Model: Cattleya2		Date: 16-May-01	No.: MB023001
Modified Article: ICs on the Video Control Board		Prepared by: H.K.	
From: Technical Service Dept., GTS Division			
Reason for Modification:	<input type="checkbox"/> Parts catalog correction <input type="checkbox"/> To facilitate assembly <input type="checkbox"/> Part standardization	<input checked="" type="checkbox"/> Vendor change <input type="checkbox"/> To improve reliability <input type="checkbox"/> Other	<input type="checkbox"/> To meet standards ()

Model: Cattleya2		Date: 17-May-01	No.: MB023002
Modified Article: Feed Rollers		Prepared by: H.Matusi	
From: Technical Services Dept., GTS Division			
Reason for Modification:	<input type="checkbox"/> Parts catalog correction <input type="checkbox"/> To facilitate assembly <input type="checkbox"/> Part standardization	<input checked="" type="checkbox"/> Vendor change <input type="checkbox"/> To improve reliability <input type="checkbox"/> Other	<input type="checkbox"/> To meet standards ()

27. Transfer Belt Unit (B032)

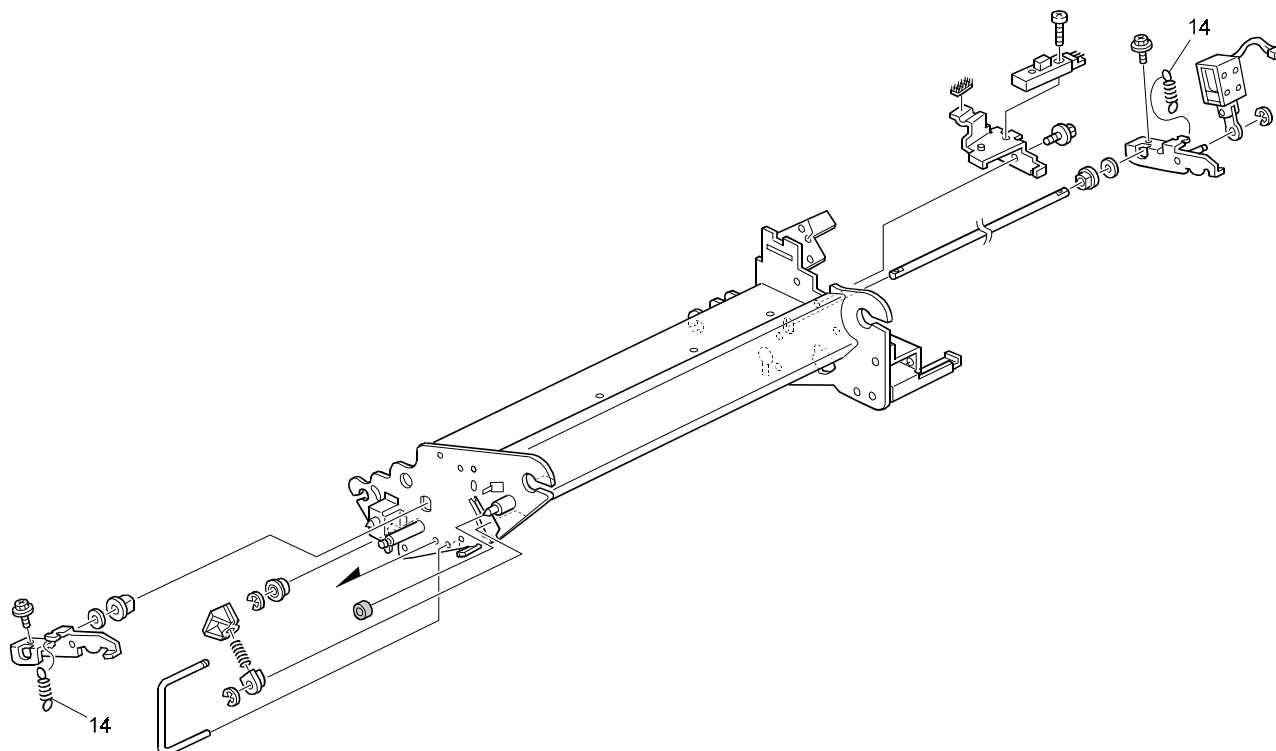
Old part number	New part number	Description	Q'ty	Int	Page	Index	Note
B0236078	B0236076	Belt Tension Spring Spring – 40.65mm	2	X/O	65	14

58. Frame Section 3 (B023)

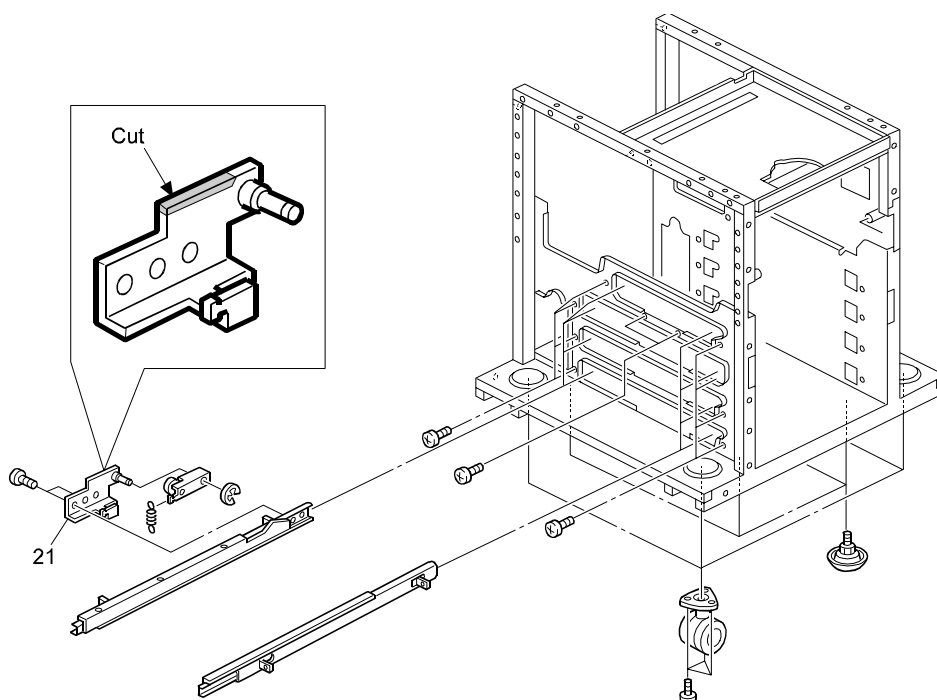
Old part number	New part number	Description	Q'ty	Int	Page	Index	Note
A1342926	B0232509	Paper Feed Lock Bracket Bracket – Paper Feed Lock	1	X/O	127	21

36. Fusing Unit 3 (B023)

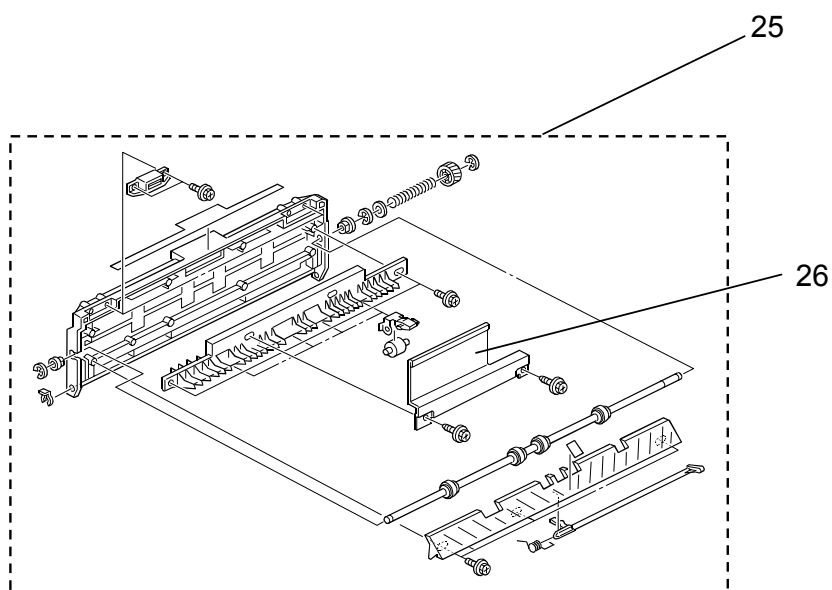
To increase the ease of opening the Paper Exit Unit, a new type of handle for the D2 area has been added. ***In addition, a sheet has been added to the fusing unit cover.***

Old part number	New part number	Description	Q'ty	Int	Page	Index	Note
<i>B0234020</i>	<i>B0234021</i>	<i>Fusing Unit – 120V</i>	<i>1</i>	<i>X/O</i>	<i>79</i>	<i>*</i>	
<i>B0234030</i>	<i>B0234031</i>	<i>Fusing Unit – 230V</i>	<i>1</i>	<i>X/O</i>	<i>79</i>	<i>*</i>	
B0234079	B0234080	Paper Exit Unit	1-1	X/O	83	25	
	B0234157	Exit Unit Handle	0-1		83	26*	
A2574101	B0234108	Fusing Cover	1-1	X/O	79	30	
	B0234160	Sheet - 20X95	0-1		79	39*

24. Drawer Unit 2 (B023)

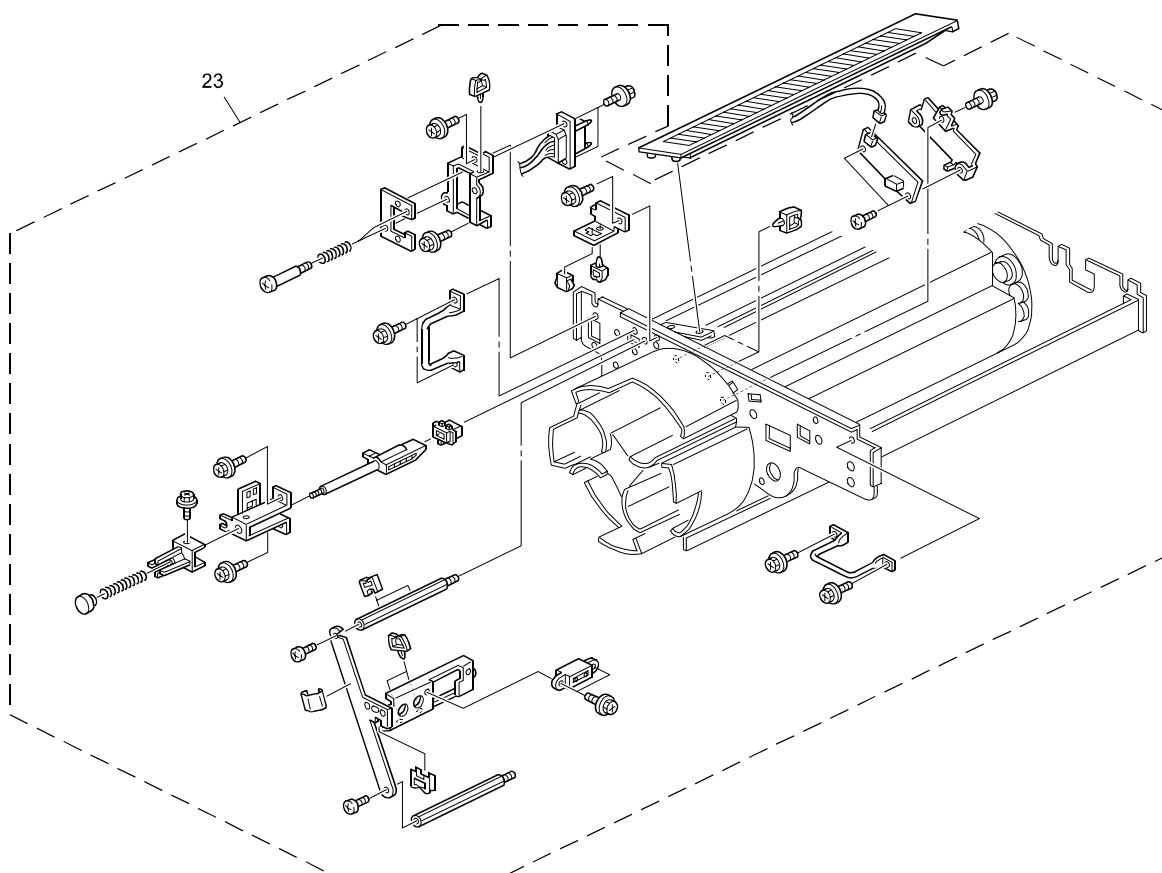
Due to a vendor change, the P/N for the Drawer Unit has been changed as follows. Please note that these two parts are interchangeable (O/O).

Old part number	New part number	Description	Q'ty	Int	Page	Index	Note
B0233021	B0233022	Drawer Unit	1	O/O	59	23

35. FUSING UNIT 2 (B023)

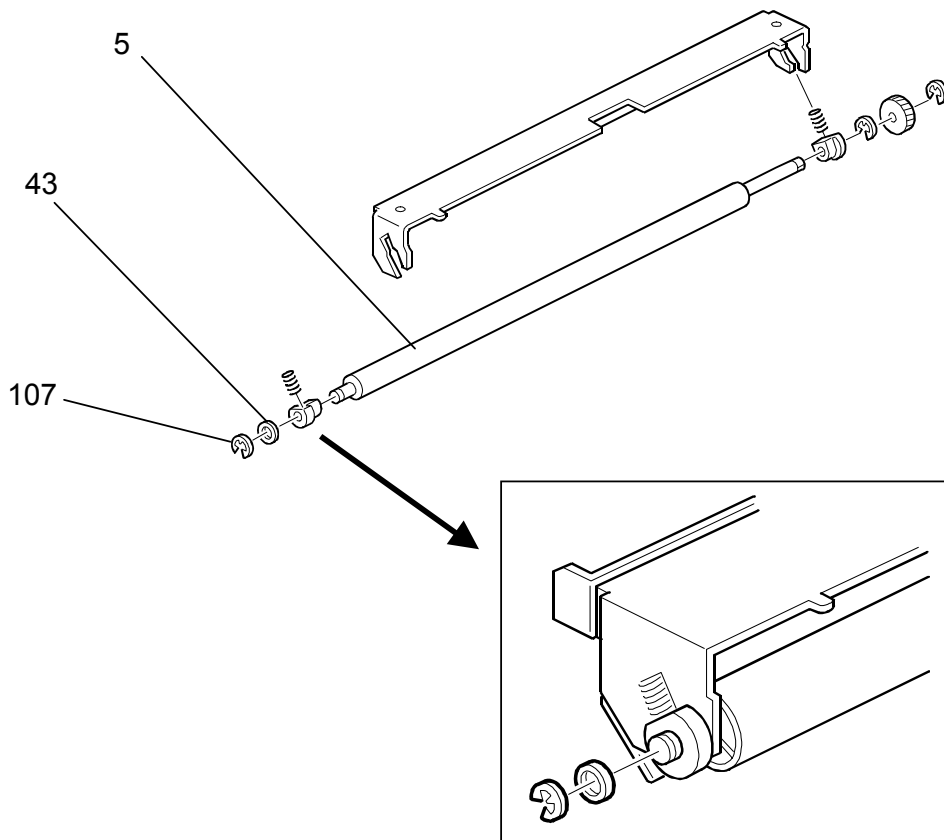
To increase the reliability of the Fusing Cleaning Roller, a spacer has been added between the bushing and the retaining ring. In addition, the Retaining Ring has been changed from an M5 to an M4 type.

Old part number	New part number	Description	Q'ty	Int	Page	Index	Note
<i>B0234023</i>	<i>B0234024</i>	<i>Fusing Unit – 120V</i>	<i>1</i>	<i>X/O</i>	<i>79</i>	<i>*</i>	
<i>B0234033</i>	<i>B0234034</i>	<i>Fusing Unit – 230V</i>	<i>1</i>	<i>X/O</i>	<i>79</i>	<i>*</i>	
AE042044	AE042053	Fusing Cleaning Roller	1-1	X/X	81	5	X/O as a set
	AA132219	Spacer	0-1		81	43	
	07200040B	Retaining Ring – M4	0-1		81	107	
07200050B		Retaining Ring – M5	1-0		81	106

35. Fusing Unit 2 (B023)

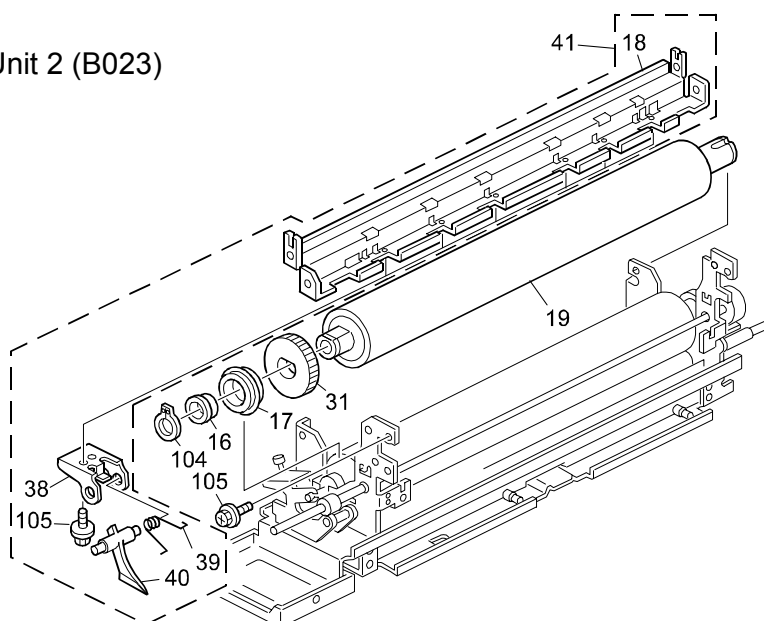
Old part number	New part number	Description	Q'ty	Int	Page	Index	Note
<i>B0234025</i>	<i>B0234026</i>	<i>Fusing Unit – 120V</i>	<i>1</i>	<i>X/O</i>	<i>79</i>	<i>*</i>	
<i>B0234035</i>	<i>B0234036</i>	<i>Fusing Unit – 230V</i>	<i>1</i>	<i>X/O</i>	<i>79</i>	<i>*</i>	
B0234069	B0234068	Stripper Pawl Stay	1-1	X/O	81	41	
B0234148	B0234147	Magnet Catch Stay	1-1	X/O	81	18	
B0234264	B0234263	Stripper Pawl Holder	1-1	X/O	81	38

44. DRIVE SECTION (B023)

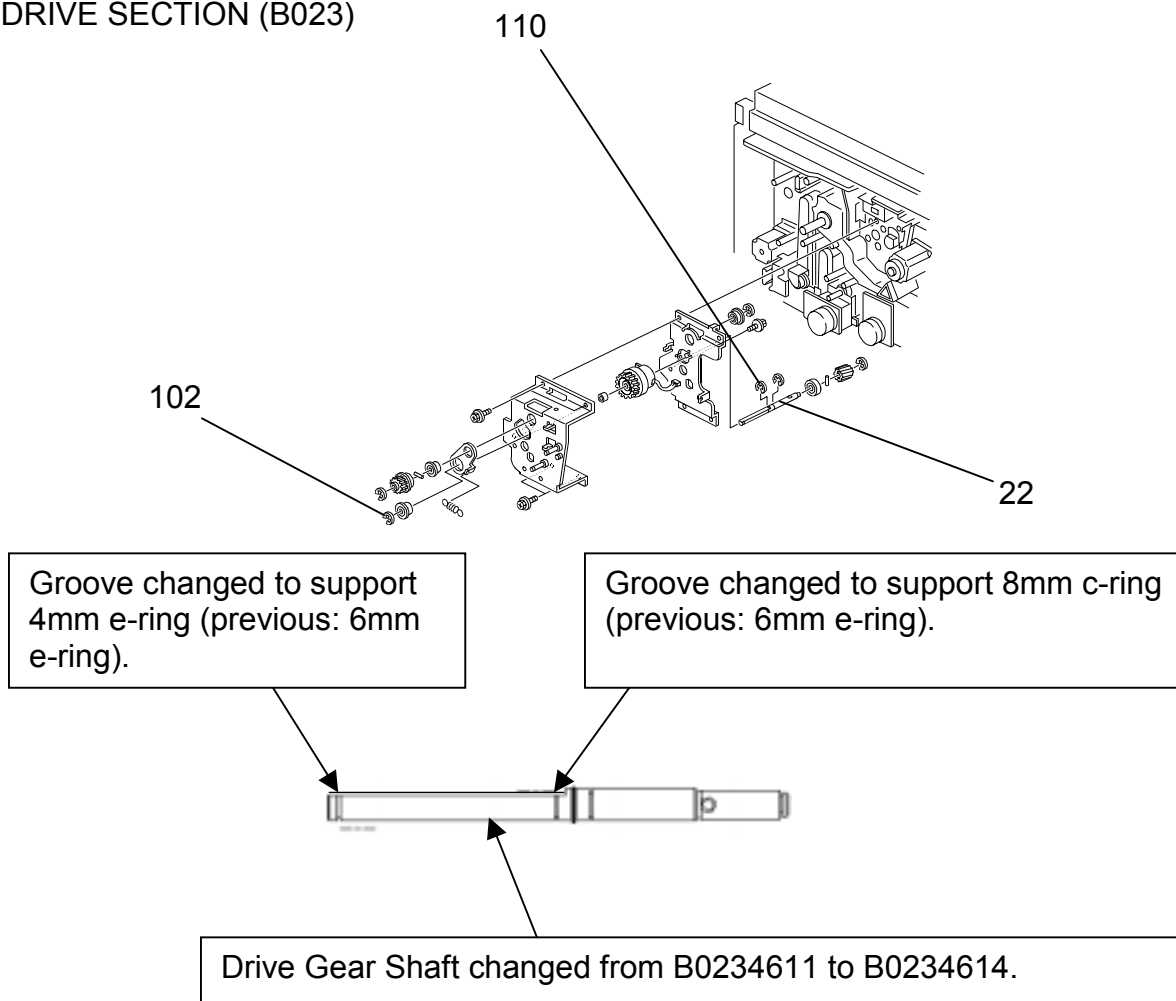
Note: The older shaft (B0234611) is no longer available from SPC.

44. DRIVE SECTION (B023)

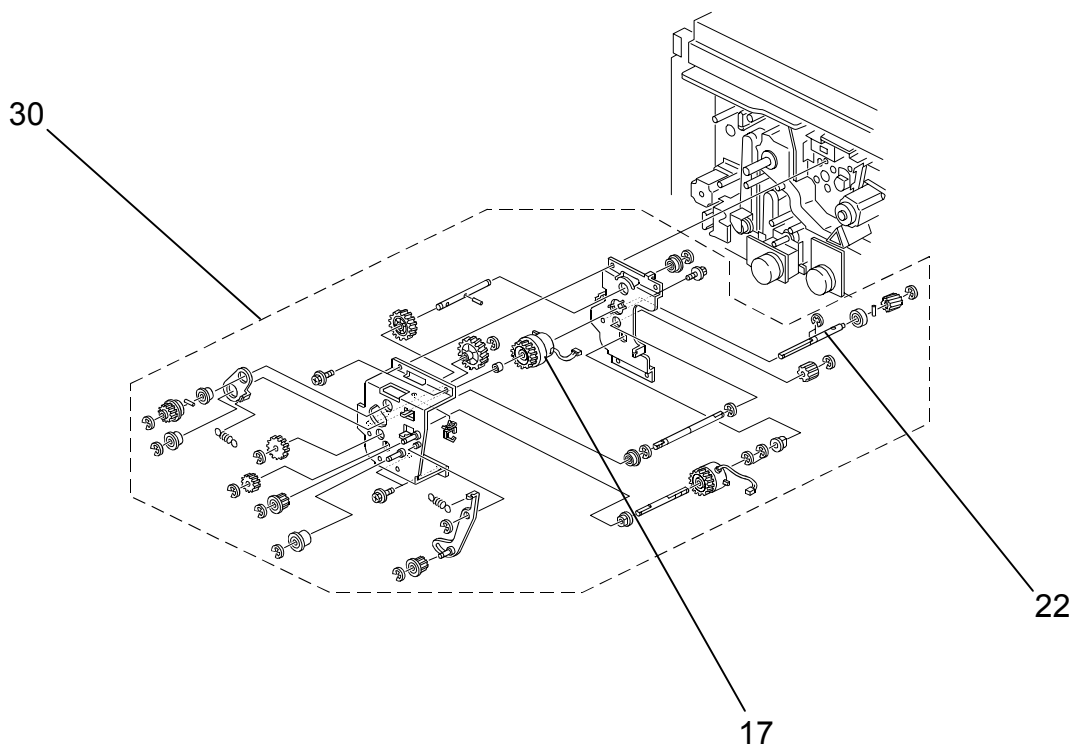
Old part number	New part number	Description	Q'ty	Int	Page	Index	Note
	B0234655	Development Drive Unit	0-1	-	99	30	New Item
AX210080	AX210083	Magnetic Clutch	1-1	X/X	99	17	X/O as a set
B0234614	B0234615	Drive Gear Shaft	1-1	X/X	99	22

36. Fusing Unit 3 (B023)

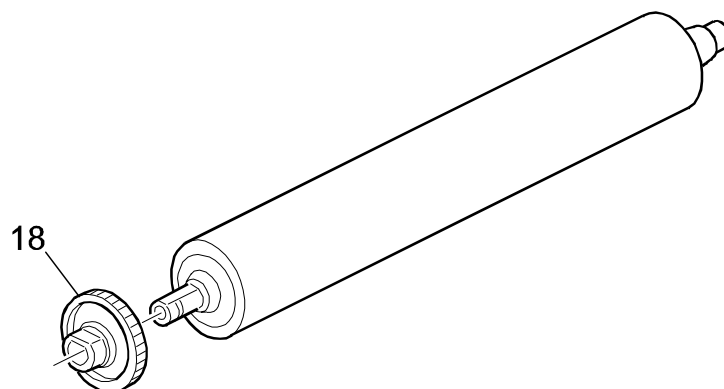
To improve the reliability of the Pressure Roller Gear, its material has been changed from plastic to metal and the shape of the gear teeth has been modified.

Old part number	New part number	Description	Q'ty	Int	Page	Index	Note
<i>B0234024</i>	<i>B0234025</i>	<i>Fusing Unit – 120V</i>	<i>1</i>	<i>X/O</i>	<i>79</i>	<i>*</i>	
<i>B0234034</i>	<i>B0234035</i>	<i>Fusing Unit – 230V</i>	<i>1</i>	<i>X/O</i>	<i>79</i>	<i>*</i>	
B0234239	B0234241	Gear 58Z	1-1	X/O	83	18

26. DRAWER UNIT 4 (B023)

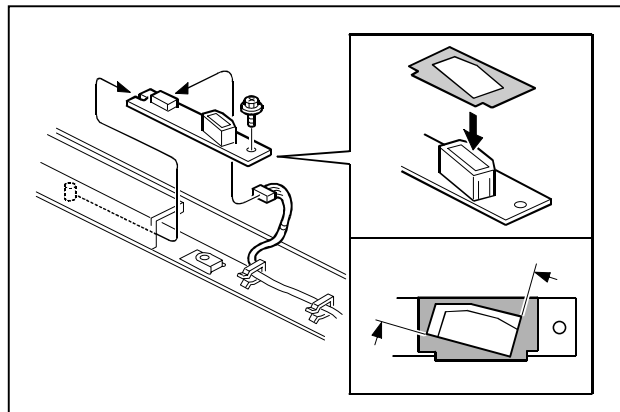
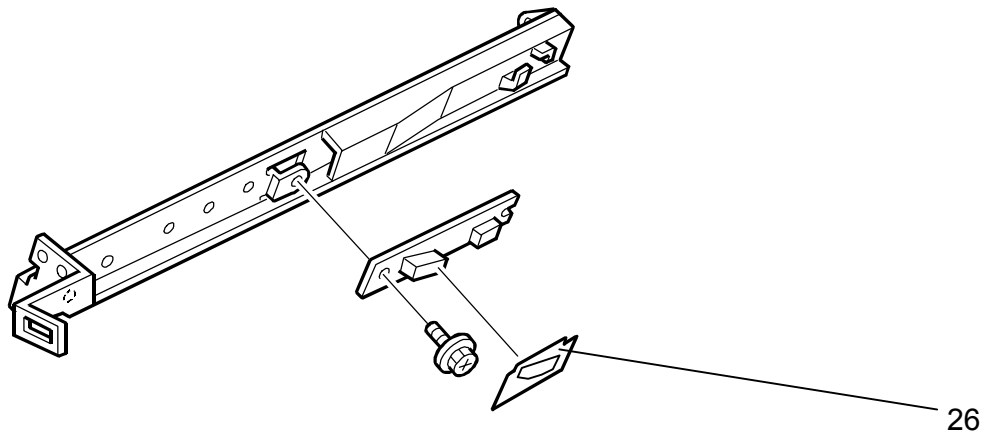
To improve the performance reliability of the ID sensor, an ID Sensor Seal has been newly added. This new seal ensures that the sensor does not become dirty with toner, which can lead to SC385 (ID sensor Vsg Adjustment Error).

Old part number	New part number	Description	Q'ty	Int	Page	Index	Note
	B0232345	ID SENSOR SEAL	1	-	63	26	New Index

27. TRANSFER BELT UNIT (B023)

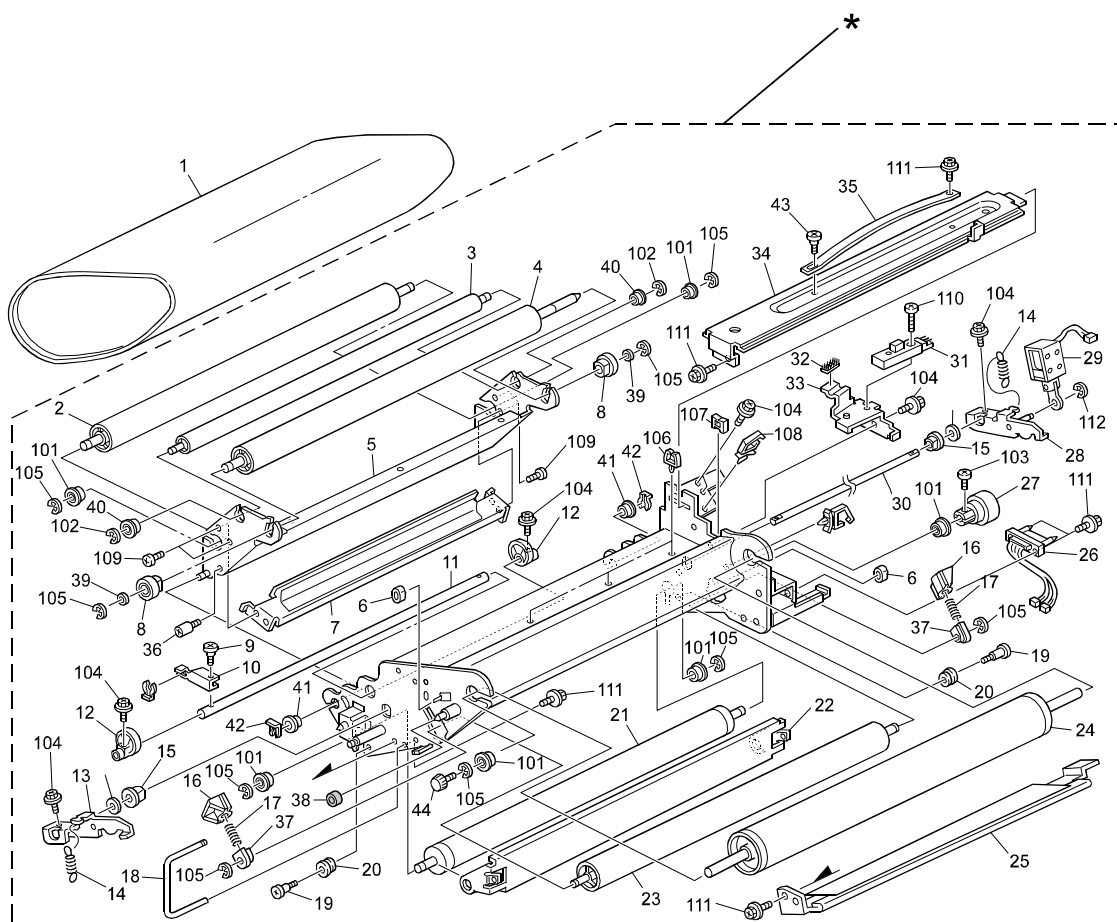
Please replace the illustration with the new one below on page 64 of the Cattleya2 parts catalog.

The corrected point: The dotted line around the ITB unit assembly that excludes the Transfer Belt is added. This is because the ITB unit assembly does not include the belt.

26. DRAWER UNIT 4 (B023)

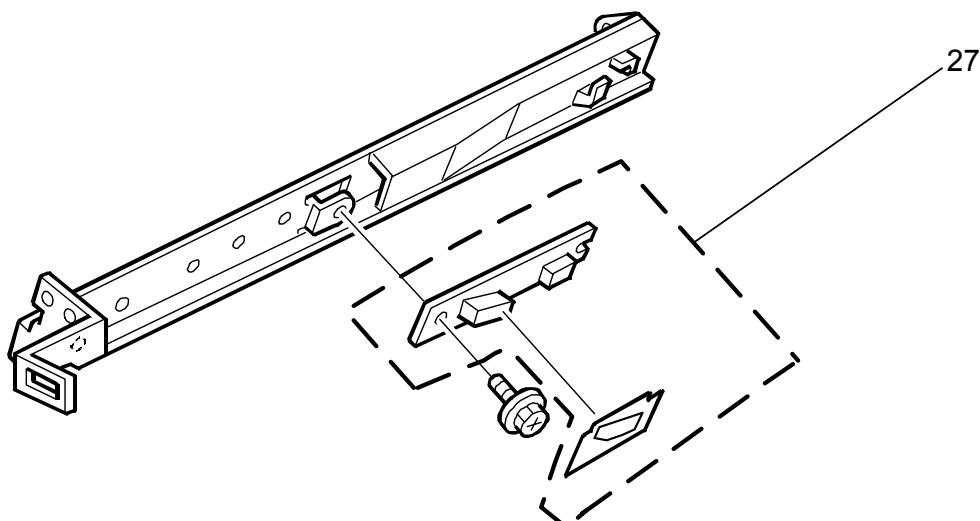
Old part number	New part number	Description	Q'ty	Int	Page	Index	Note
	B0232343	ID SENSOR ASSY	1	-	63	27	New Index

43. DRIVE SECTION 1 (B023)

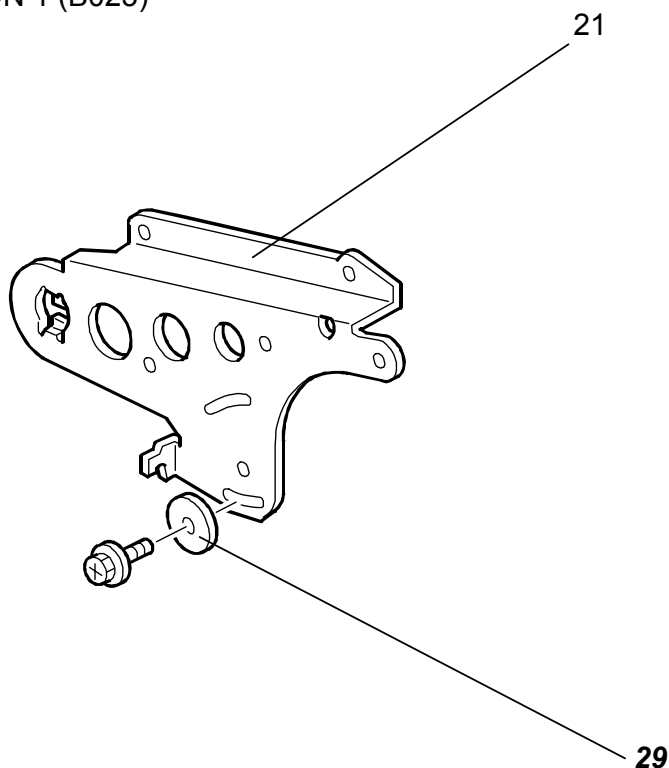
A washer has been added as shown below to ensure the Timing Belt is not damaged when it slides along the pulley. The washer prevents the belt from sliding by not allowing the pulley shaft to incline.

34. FUSING UNIT 1 (B023)

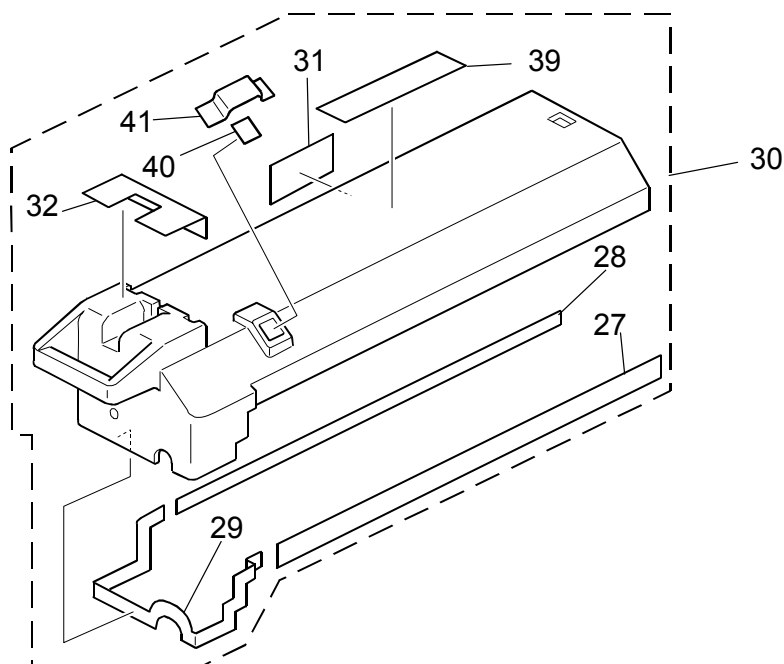
Old part number	New part number	Description	Q'ty	Int	Page	Index	Note
B0234350	B0234349	Fusing Cover	1-1	O/O	79	30	*
	B0234352	Cover Bracket	0-1	-	79	40*	
	B0234354	Sheet – 70X26	0-1	-	79	41*

Note: Although the shape of the fusing cover has been slightly modified by adding the two new parts above, the interchangeability on this model is O/O.
